## Product Change Notification / LIAL-10HDQI000

CCB 3104.005 Final Notice: Qualification of MPHL as a new final test site for selected ATMEGA48xx, ATMEGA88xx and ATMEGA168xx device families available in 32L TQFP (7x7x1mm) package.

**CCB 3104.005**  
**Pre and Post Change Summary**  
**PCN#: LIAL-10HDQI000**

**PCN #: LIAL-10HDQI000**

**ANAP**

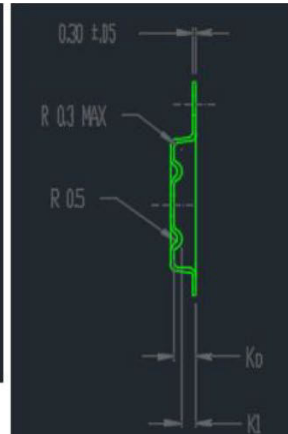
# Tape and Reel - Carrier Tape

W	P	Ao	Bo	Ko	K1
16.00 (+/- 0.30)	12.00 (+/- 0.10)	9.30 (+/- 0.10)	9.30 (+/- 0.10)	1.80 (+/- 0.10)	1.20 (+/- 0.10)

Thickness	Color
0.30 (+/- 0.05)	Black

## MPHL

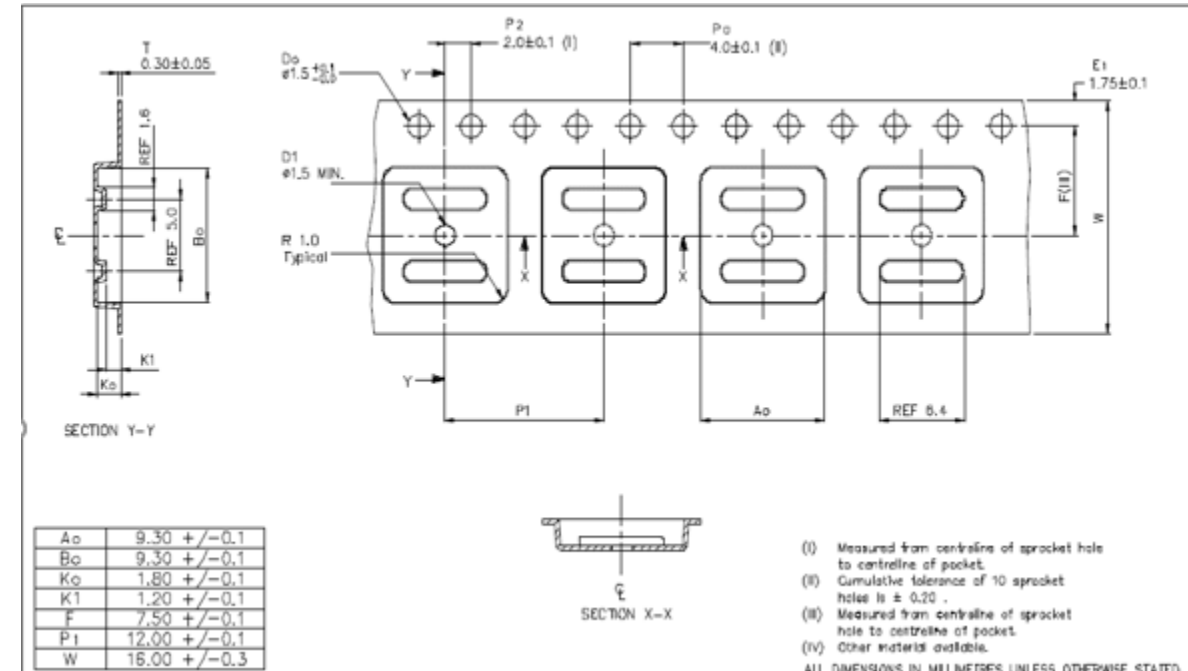
W: 16 mm

P1: 12 mm

A0: 9.30 mm

B0: 9.30 mm

K0: 1.80 mm

K1: 1.20 mm

# Tape and Reel – Packaging

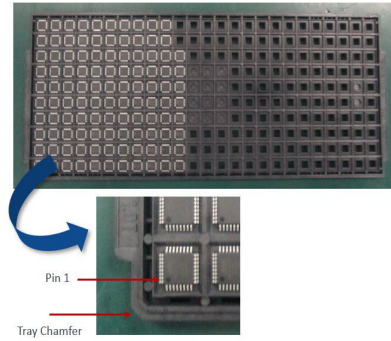
Final Test Site	ANAP	MPHL
Desiccant		
Antistatic Bag		
Boxes

# Tray - BQM and Pin 1 Orientation

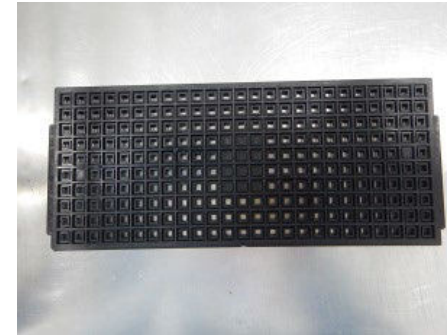
ANAP	MPHL
Base Quantity Multiple (BQM)	250	250
Pin 1 orientation	Pin1 near Tray Chamfer	Pin1 near Tray Chamfer
